STAFF RECOMMENDATION
1911 Ashwood Avenue
April 20, 2016

Application: New construction—addition; Setback determination
District: Belmont-Hillsboro Neighborhood Conservation Zoning Overlay
Council District: 18
Map and Parcel Number: 10416012000
Applicant: Jennifer Bagwell
Project Lead: Melissa Baldock, melissa.baldock@nashville.gov

<p>Description of Project: Application is to construct a rear addition. The addition requires a side setback determination.</p> <p>Recommendation Summary: Staff recommends approval of the project with the condition that staff approve the window selections prior to their purchase and installation.</p> <p>With this condition, staff finds that the proposed addition and setback determination meet Sections II.B.1. and II.B.2. of the <i>Belmont-Hillsboro Neighborhood Conservation Zoning Overlay: Handbook and Design Guidelines</i>.</p>	<p>Attachments A: Site Plan B: Elevations</p>
--	--

Figures 2 & 3 show the existing addition.

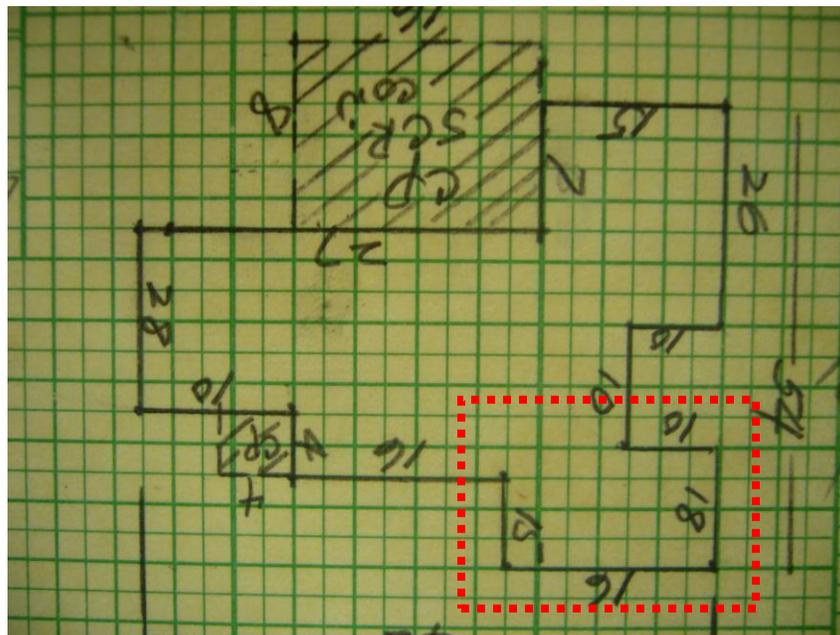
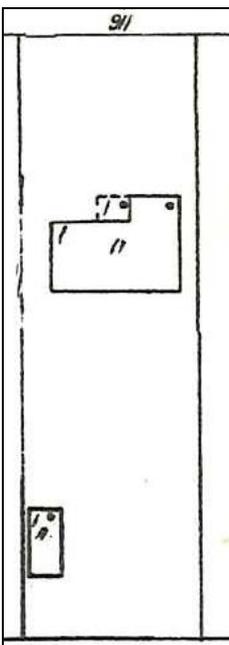
Location & Removability: The new addition will attach to an existing addition (Figures 2 & 3). The date of construction of the existing addition is unknown, but it was likely constructed between 1957 and 1968. It appears in a 1968 footprint drawing of the structure in the Property Assessor's files, but does not appear on the 1957 Sanborn Map (Figures 4 & 5). By attaching the new addition to the existing rear addition, it could be removed in the future without affecting the historic character of the 1930s house. Staff therefore finds that the proposed addition meets Section II.B.2.a and II.B.2.e. of the design guidelines.

ASHWOOD AVENUE (50')

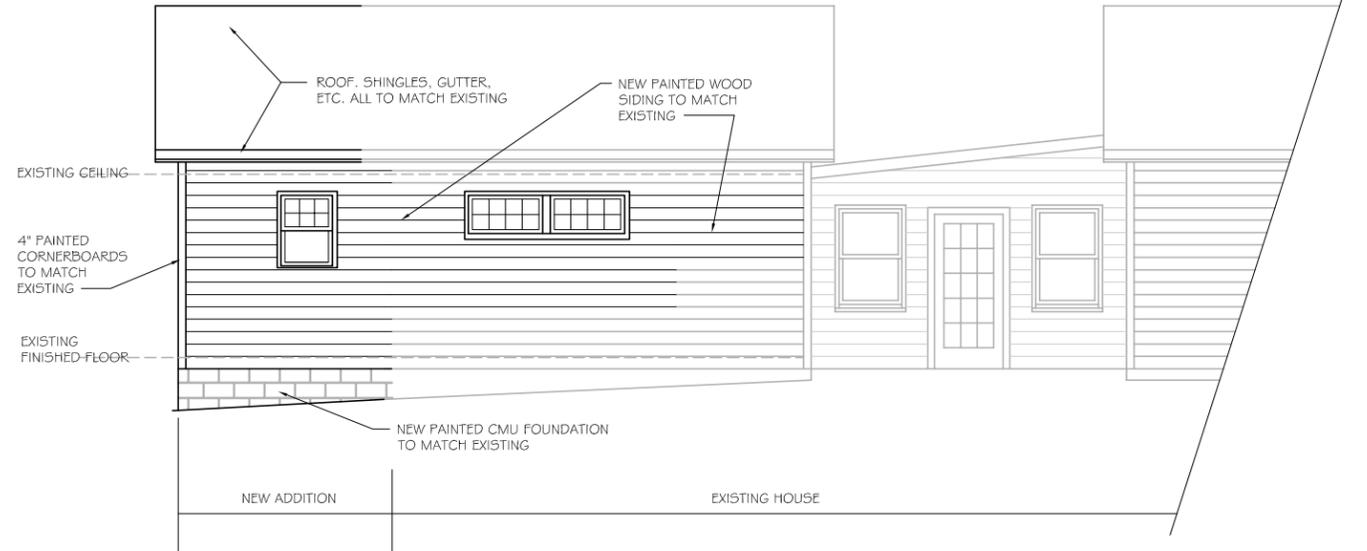
Setback & Rhythm of Spacing: The proposed addition requires a side setback determination. Base zoning requires that the addition be a minimum of five feet (5') from the side property line. In this case, the existing addition is between five feet and five feet six inches (5'-5'6") from the left side property line. The historic house and the existing addition are slightly angled on the property, so that when the existing addition is extended nine feet, it will be about four feet, six inches (4'6") from the left side property line. Staff finds the proposed four foot, six inch (4'6") side setback appropriate in this instance because the new addition will not be any wider than the existing addition. Also, the new addition is relatively modest in size, at just nine feet, three inches (9'3") deep. Moreover, the six inch (6") encroachment into the setback area will not significantly impact the historic house or its historic neighbors. Staff therefore finds that the addition's proposed setback meets Sections II.B.1.c. and II.B.2. of the design guidelines.

NEW SOUTH ELEVATION

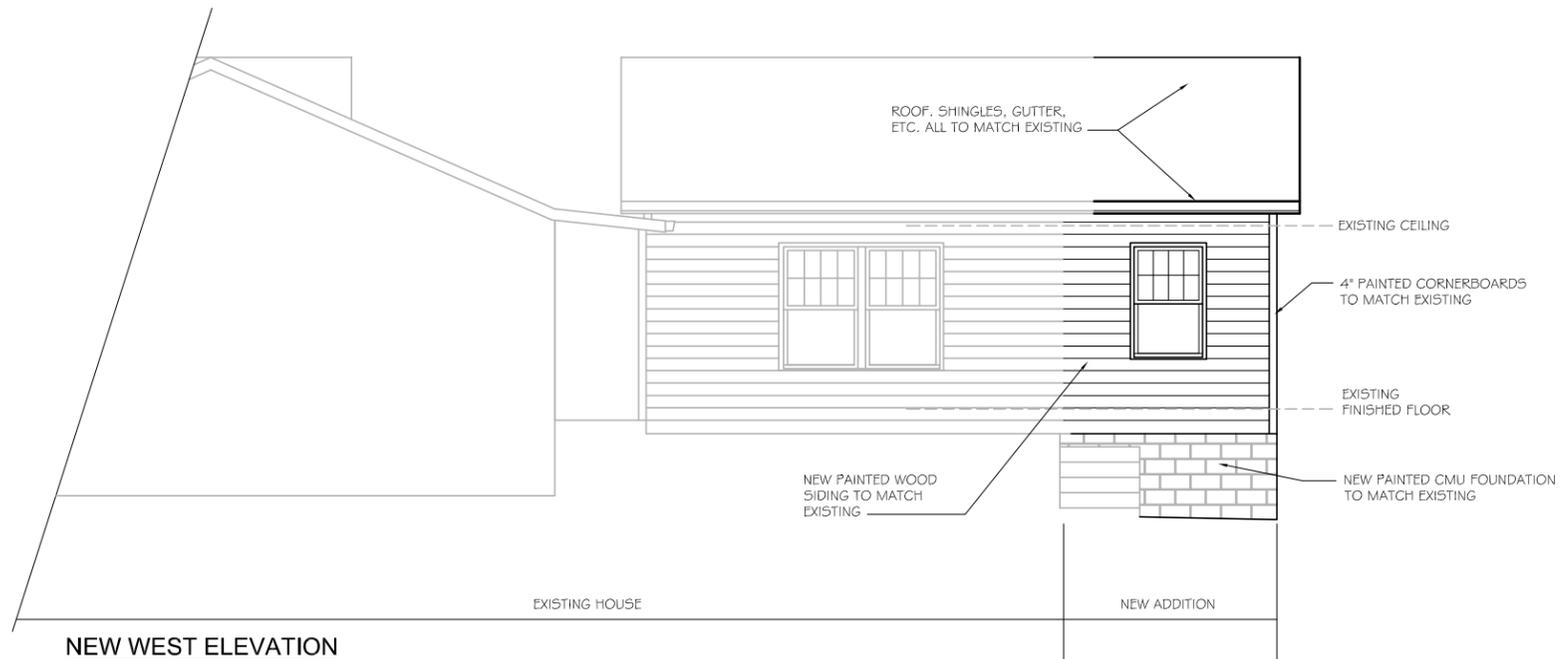
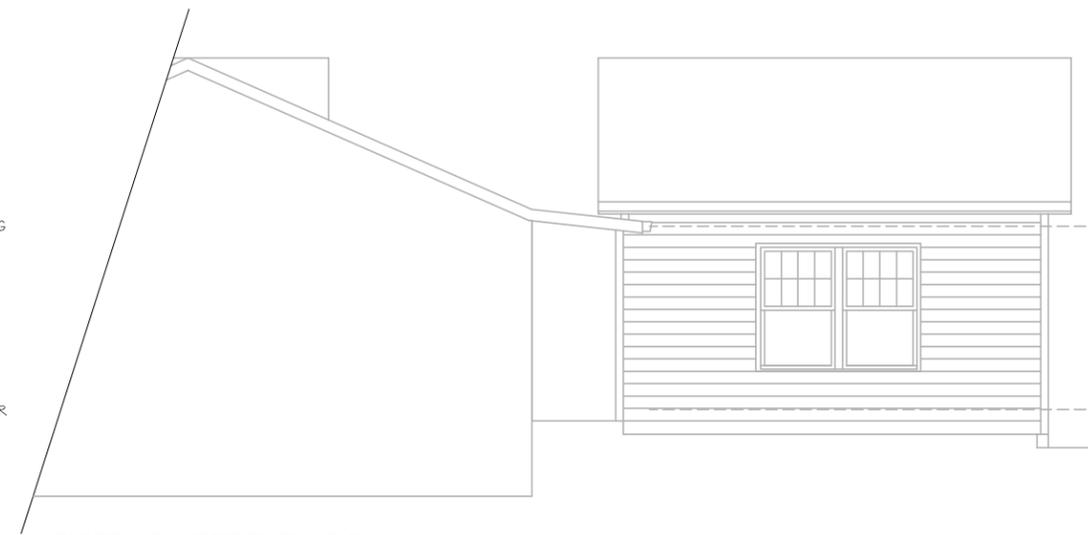
Height & Scale: The addition will match the foundation, eave, and ridge height of the existing addition. It will have a maximum foundation height of two feet (2'), a maximum eave height of eleven feet (11'), and a maximum ridge height of eighteen feet (18'). The addition will add about nine feet, three inches (9'3") to the depth of the existing addition. It will match the width of the existing addition, which is sixteen feet, three inches

Materials: The new addition will match the materials of the existing addition, and include wood siding, painted cement block foundation, and asphalt shingles in a color to match the existing. Staff recommends approval of the window selections prior to purchase and installation. With this condition, staff finds that the proposed materials meet Sections II.B.1.d. and II.B.2. of the design guidelines.

Roof form: The roof of the new addition will match the gable form, pitch, eave, and ridge height of the existing addition's roof. Staff therefore finds that the proposed roof meets Section II.B.1.e. and II.B.2. of the design guidelines.

Proportion and Rhythm of Openings: No changes to the window and door openings on the historic house were indicated on the plans. The windows on the proposed addition will be located over sixty feet (60') from the front of the house and over one hundred feet (100') from the street. They will be at most minimally visible, and staff finds that they meet Sections II.B.1.g. and II.B.2. of the design guidelines.

Recommendation Summary: Staff recommends approval of the project with the condition that staff approve the window selections prior to their purchase and installation.
